Subject: Application for a Site Certificate for the Biglow Canyon Wind Farm Facility

Supplement to the
Site Certificate Application for the
Biglow Canyon Wind Farm

**Supplement
to the Site Certificate Application
for the
Biglow Canyon Wind Farm
Sherman County, Oregon**

Figure C-2
Wind Farm Facilities

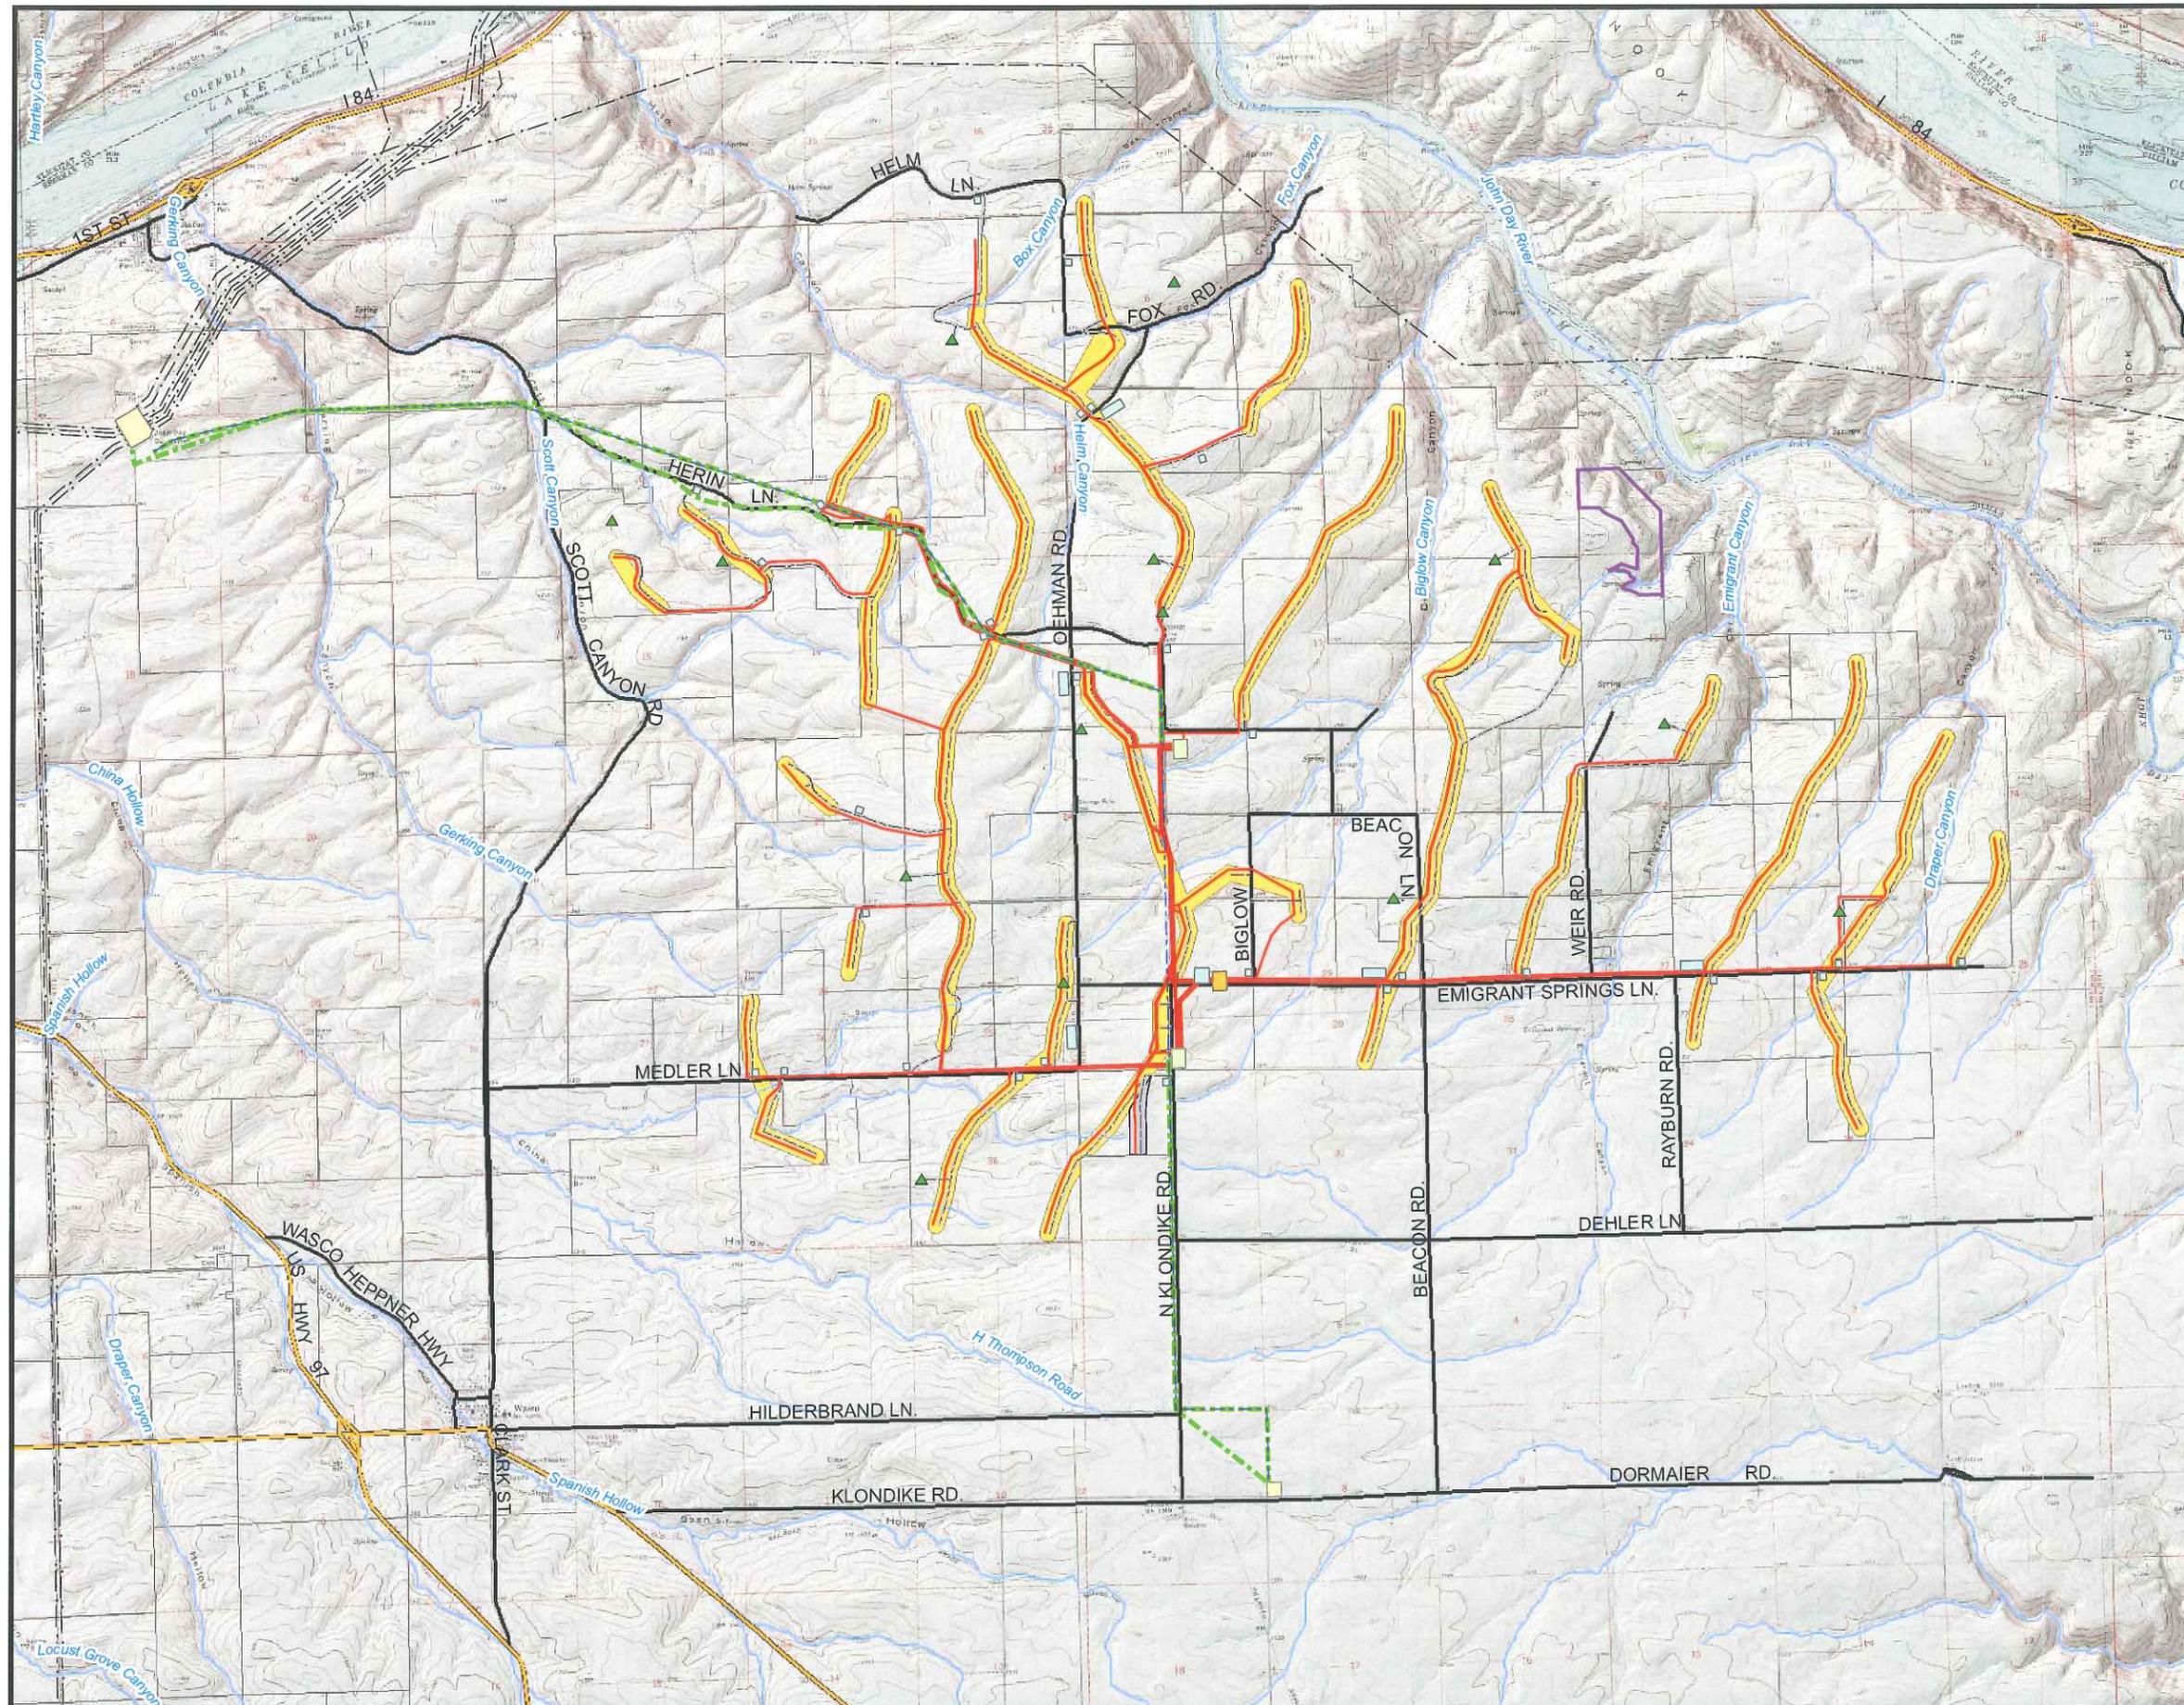
(Exhibit C, Section C.1, page C-1) Provide full-size USGS 7.5-minute quadrangle maps showing the proposed locations of the energy facility site, and all related or supporting facility sites, in relation to major roads, water bodies, cities and towns, important landmarks and topographic features.

Four copies of Figure C-2 on a full-size U.S. Geological Survey (USGS) 7.5-minute quadrangle map have been submitted by CH2M HILL under separate cover to the Oregon Department of Energy (the Department or ODOE). An 11x17 version of revised Figure C-2 is included in Supplemental ASC, Attachment C-1 (please see the Additional Information subsection below for a description of Figure C-2 revisions).

The following revisions have been made to the facilities layout in Figure C-2 (attached) and are highlighted in Figure C-2A (attached):

- Removal of a small piece of the turbine corridor located in the northwestern portion of the Facility area. Approximately 0.4 mile of the western half of the corridor will be removed. This modification reduces permanent disturbance areas and habitat impacts.

Figure K-1 Zoning Map

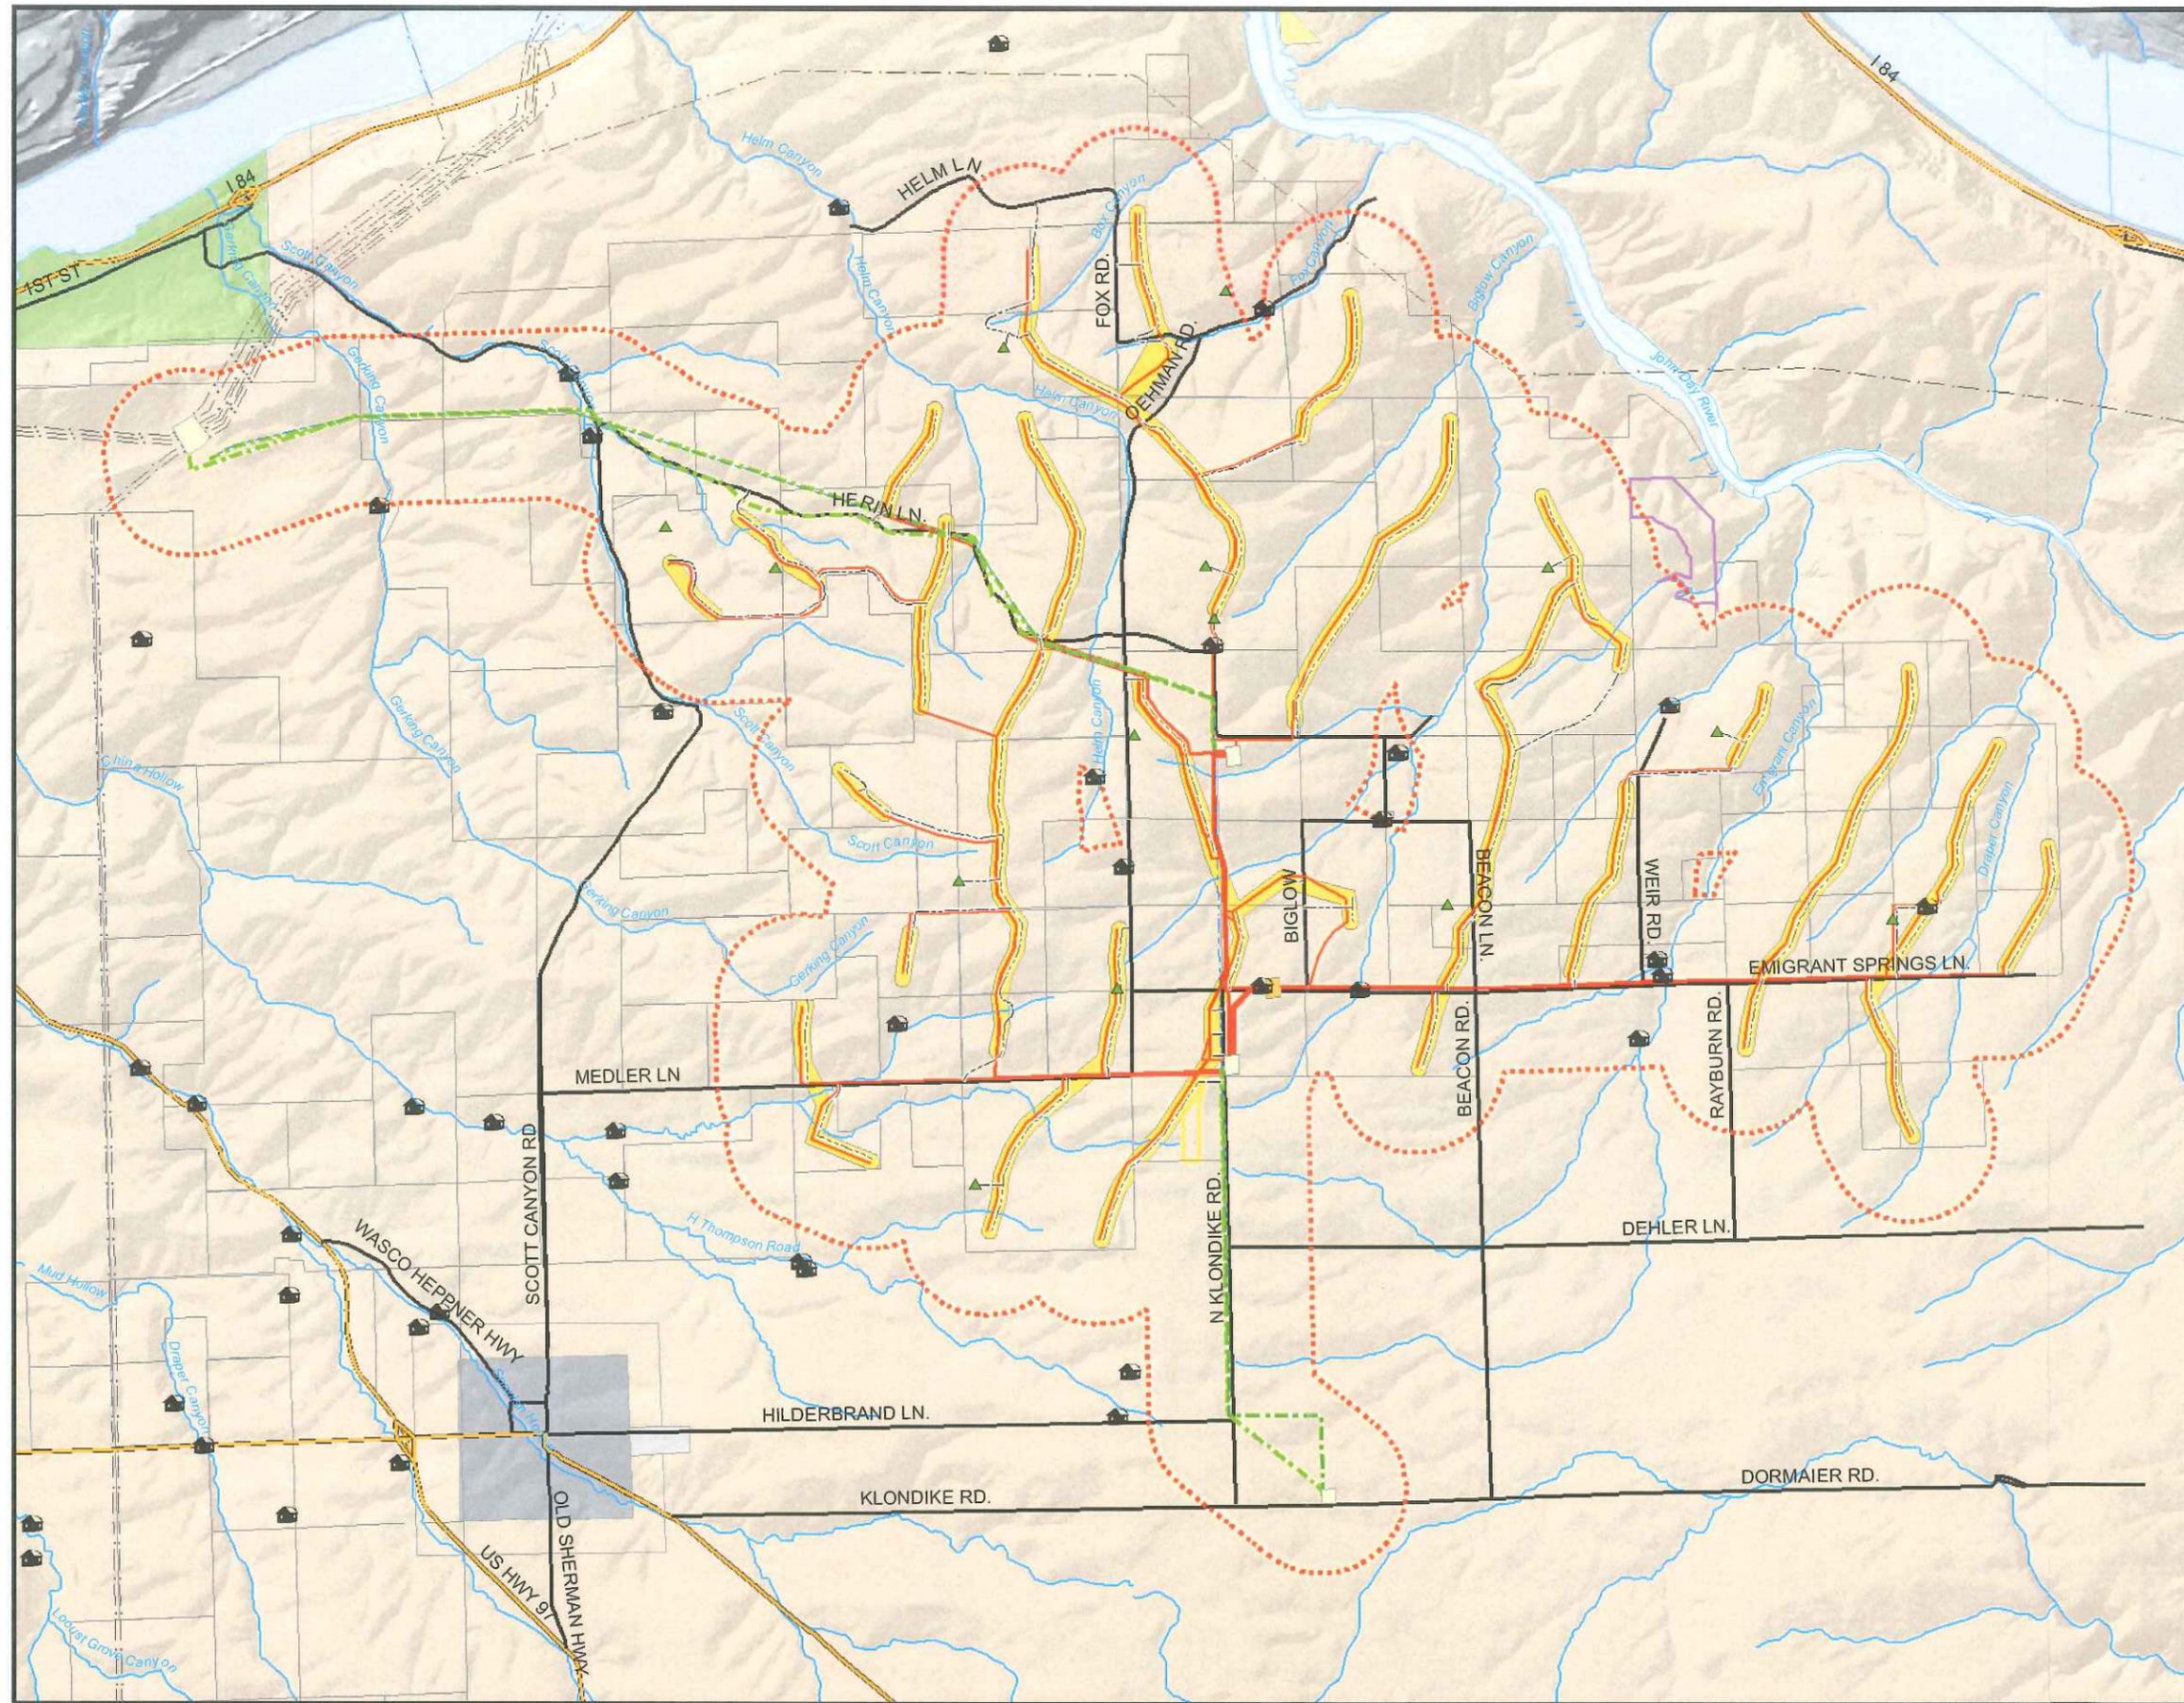
The map provided to comply with OAR 345-021-0010(1)(k)(A) does not show comprehensive plan designations (although the narrative says it does.) The map shows only the zoning. The RAIs should request a revised map that includes comprehensive plan designations.

Figure K-1 (and the Agricultural Zone shown within the figure) provides an accurate description of the Sherman County Comprehensive Plan (SCCP or Comprehensive Plan) land use designation and is not inconsistent with the Comprehensive Plan.

Figure K-1 depicts the Facility location; shows the Sherman County land use zones of the Facility site and property adjacent to the site; shows all areas of the site that might be temporarily disturbed during the design, construction, and operation of the Facility; and identifies a half-mile land use study area around the proposed Facility and all related or supporting facilities. Figure K-2 depicts actual land uses within the study area. The SCCP map does not delineate zoned Agricultural Lands as either Rangeland or Cropland. However, according to the Sherman County Planning Department, the zoning designations shown on Figure K-1 are derived, in part, from the SCCP and are not inconsistent with the various land use designations described in the SCCP (Georgia Macnab, Sherman County Planning Department, pers. comm., 2006).

Figure R-8: Revised ZVI Analysis

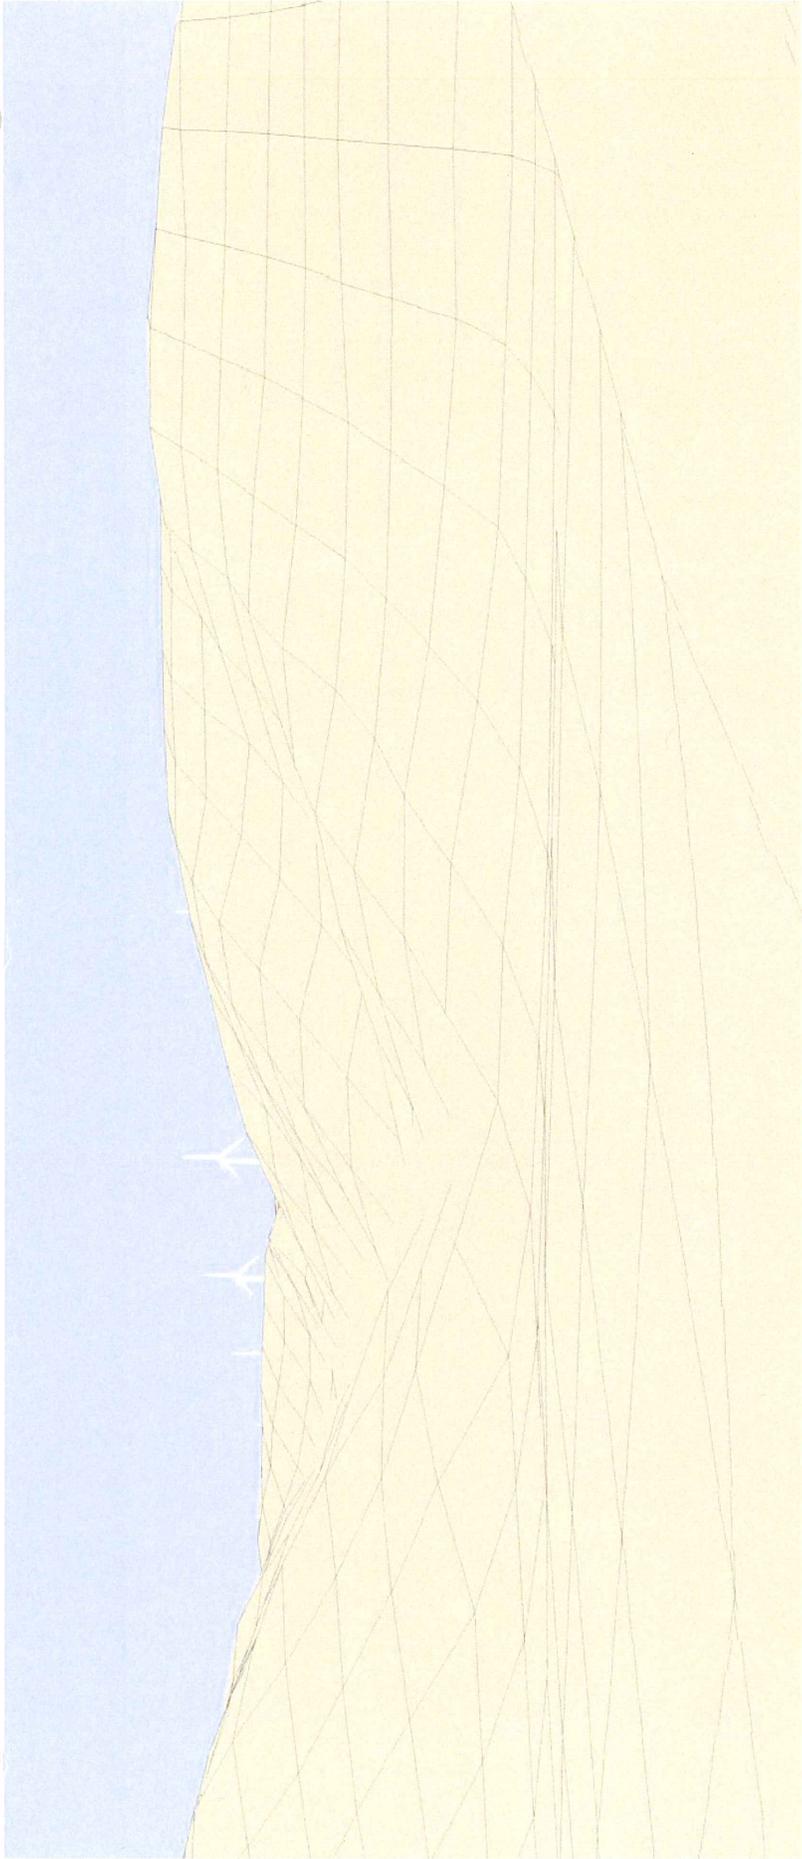
- a. BLM notes the difficulty in using Figure R-3 to determine where along the John Day Wild and Scenic River Biglow turbines would be visible. Please use BLM's suggestion of contrasting colors or another method for clearly depicting locations. In reference to item R.1.c below, please check with BLM about whether the Wild and Scenic River boundaries depicted on Figure R-3 are accurately depicted. The BLM contact is Heidi Mottl at (541) 416-6718.

- c. BLM notes that the Federal Wild and Scenic River boundary is not a set distance from the center of the river, but is an identified boundary that varies in width between $\frac{1}{4}$ mile and 1 mile in the reach between Rivermile 10 and Rivermile 21. (See Plate 1 of the 2001 John Day River Plan Final Management Plan. Final Management Plan.) Please correct the reference on page R-6.

The revised ZVI analysis has been completed and is included in Figure R-8 (attached). The variable Wild and Scenic River Boundaries have been confirmed with Heidi Mottl and are also shown in Figure R-8.

Correction noted to page R-6: the Federal Wild and Scenic River boundary is an identified boundary of $\frac{1}{4}$ to 1 mile, as shown in Figure 8 (attached).
